**BROOKVALE PUBLIC SCHOOL
2-8 OLD PITTWATER ROAD, BROOKVALE**

ALTERATIONS & ADDITIONS INCLUDING CONSTRUCTION OF A NEW SCHOOL HALL

**DA 2019/0411 – NORTHERN BEACHES COUNCIL
SYDNEY NORTH PLANNING PANEL REF. PPSSNH-24
PANEL MEETING 25 SEPTEMBER 2019**

3. Design of Option 1 is problematic at the detail level

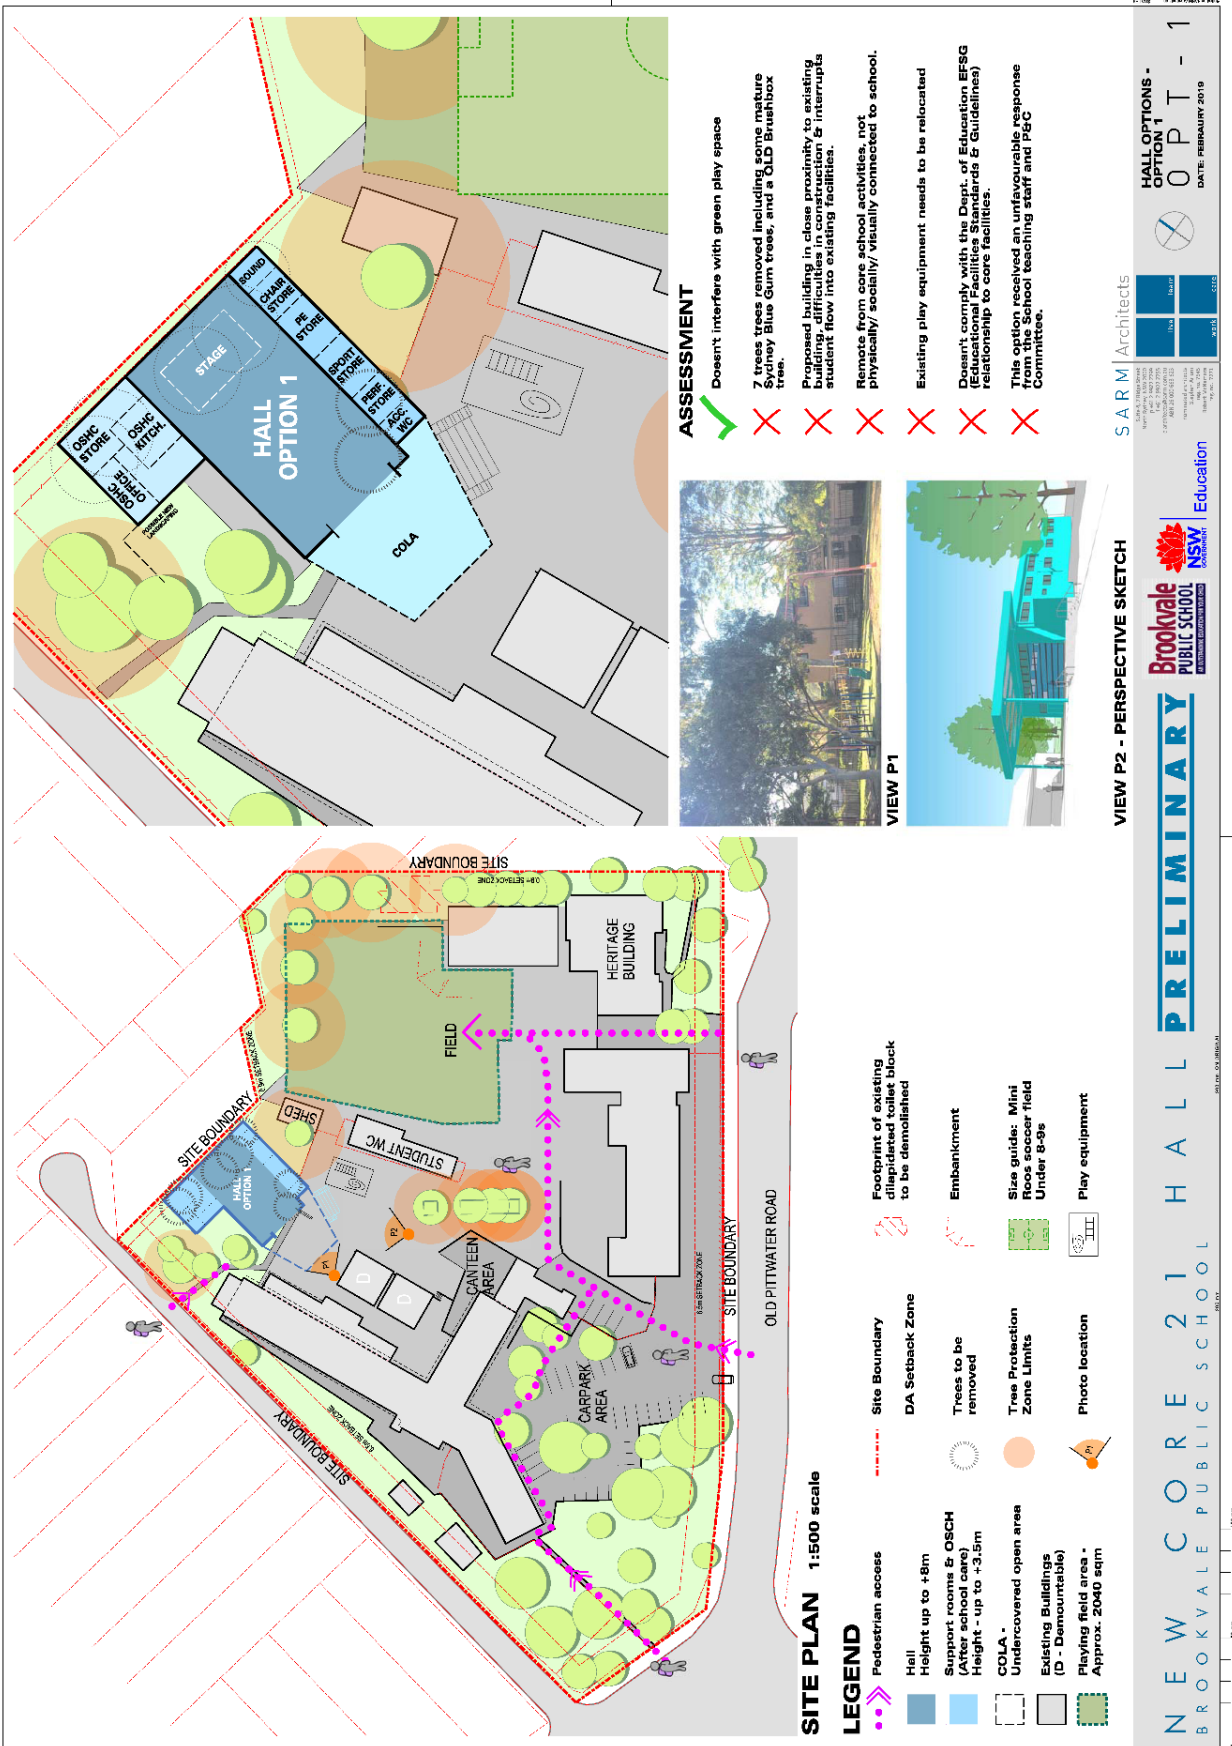
At the basic concept design level it looks like Option 1 will fit nicely into Area 1 on the high side. However when we look at the dimensions and at the ground levels there is a serious problem with Option 1.

Option 1 does not fit on the level area of ground; it overhangs the area where the ground level drops away for a 3 metre fall; the hall is intended to be 8.5m high, about the same as a 2 storey house. But when viewed from the East it would be 11.5m high, which is unacceptable in terms of the planning control of 8.5m and would dominate the site.

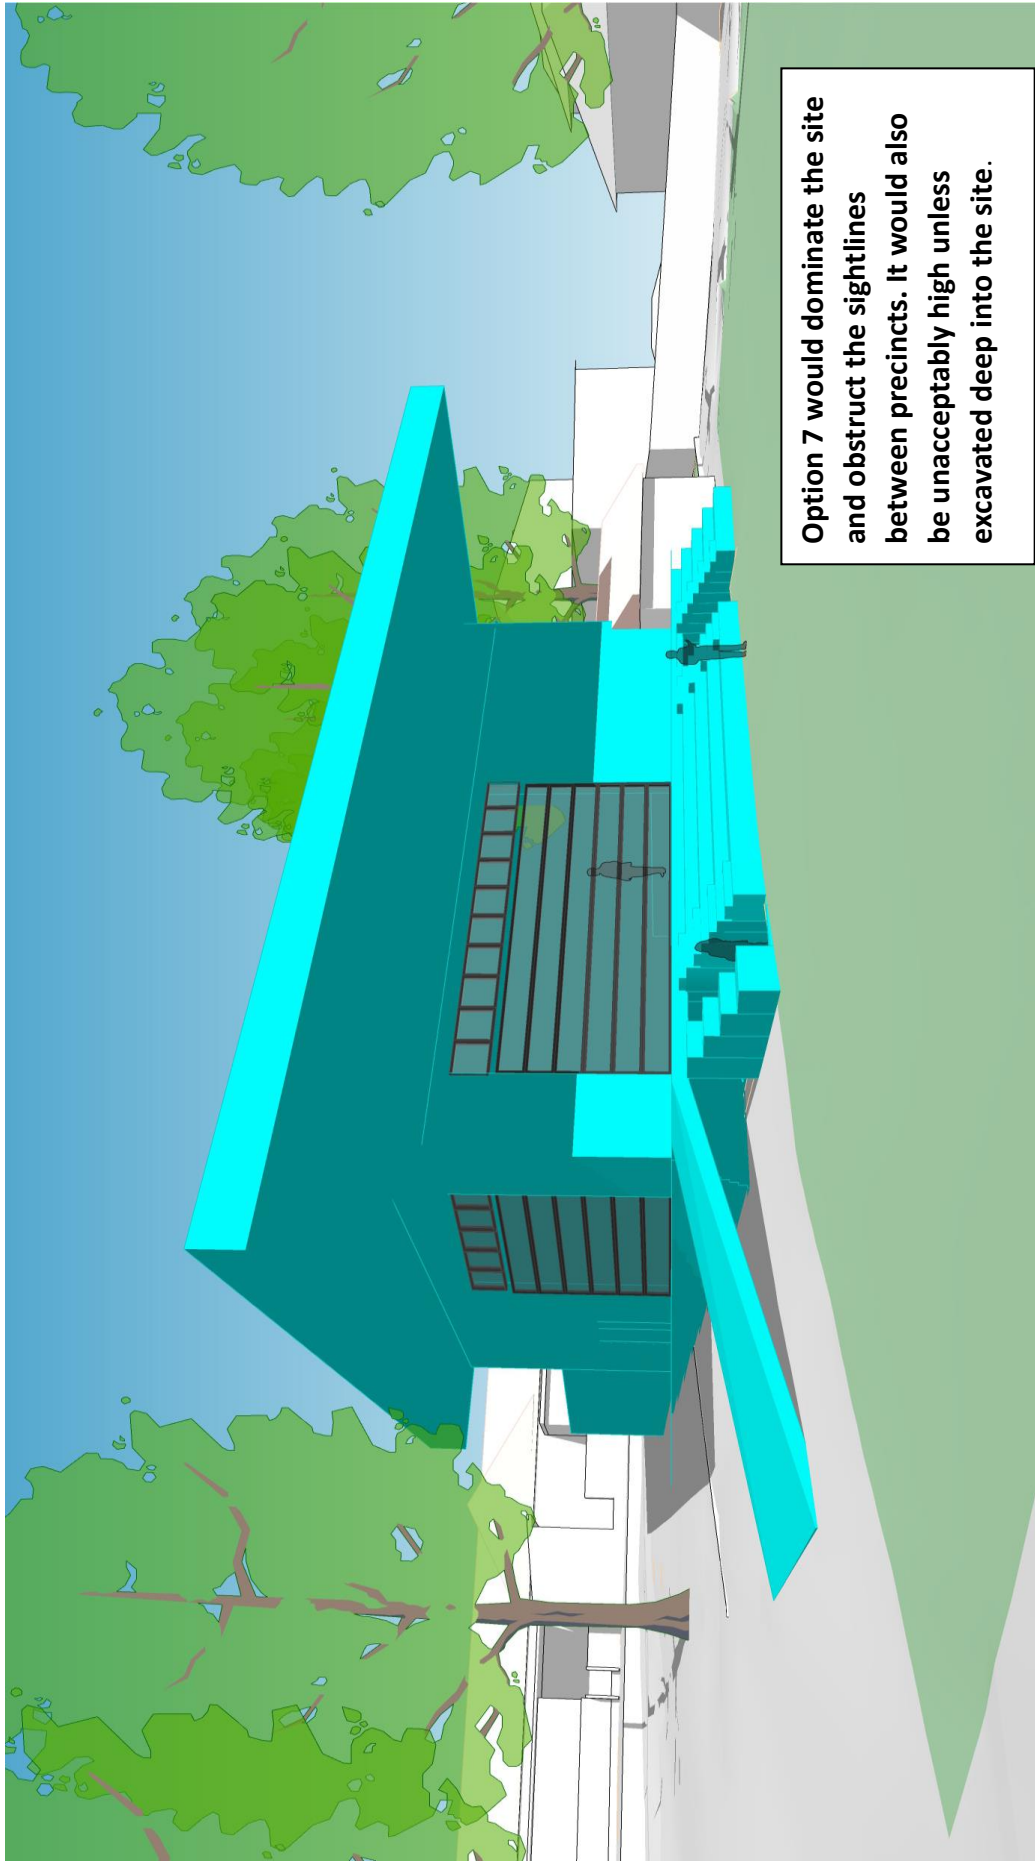
Option 7 was developed in response to comments from Council staff at a pre-DA meeting. Council staff suggested that a hall built in the centre of the site would allow all trees to be retained.

- The existing toilet block (these are the only student toilets in the school) would need to be demolished and re-built as part of this option. This would add at least \$1.0 Million to the cost of the hall. This is considered to be a waste of funds when there is sufficient space to build the hall in area 2.

- The hall in this area needs to sit off the grassed playground and due to the change in levels it would be 11 to 12 metres high when viewed from the low side, depending on exact positioning. It would dominate the site and therefore to reduce the height to an acceptable 8.5 metres would require a major excavation, with the attendant retaining walls, waterproofing and drainage to be incorporated. The additional cost of this has not been assessed but would be considerable.

- The “spill-out” of people into the exterior would place the people on a level lower than the floor level of the hall, owing to the direction of the existing slope, so the people outside would not have a clear view of the lectern. Therefore the spill-out concept would not be effective in this location unless the hall were excavated all the way down to the level of the lower playground.

- The relation with the Hall to the open play space is compromised as it is not level to allow an extension of the inside/outside relationship also limiting possible learning opportunities for large student groups.

The school management rejected this option; this option was considered the worst option to be examined.

Option 7 would dominate the site and obstruct the sightlines between precincts. It would also be unacceptably high unless excavated deep into the site.
